AMD-K6[®]-III

Processor Revision Guide

Model 9

Publication # 22473	Rev: C	Amendment/ 0
Issue Date: July 1999

Figure 1. AMD-K6[®]-III Processor Assertion of HLDA Due to Simultaneous BOFF#/HOLD Assertion

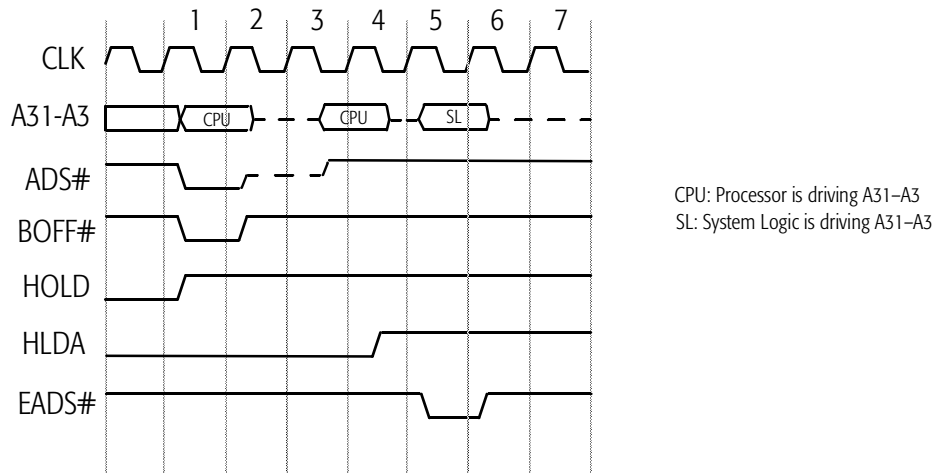
Non-conformance. If BOFF# and HOLD are sampled asserted on the same clock edge that negates ADS#, the processor asserts HLDA two clock edges after HOLD is sampled asserted.

- If the system logic asserts BOFF# for a duration of one clock, anticipates the assertion of HLDA in clock 3 (see Figure 1)—which is the normal specified operation—and drives the address bus and EADS# for an inquire cycle in clock 3, then the processor will not sample EADS# asserted. In addition, address bus contention will occur in clock 3.

- If the system logic asserts BOFF# for a duration of two clocks, anticipates the assertion of HLDA in clock 3, and drives the address bus and EADS# for an inquire cycle in clock 3, then the processor will not sample EADS# asserted. (No address bus contention occurs in this case.)

- If the system logic asserts BOFF# for a duration of one clock, anticipates the assertion of HLDA in clock 3, and drives the address bus and EADS# for an inquire cycle in clock 4, then address bus contention may occur in clock 4. (The processor will sample EADS# asserted in this case.)

If the processor does not sample EADS# asserted during an inquire cycle, cache/memory incoherency will occur. Address bus contention can affect the reliability of the processor and the system logic.

Suggested Workaround. The system logic must sample the assertion of HLDA before asserting EADS# and driving the address bus for an inquire cycle—as shown in clock 5 of Figure 1.
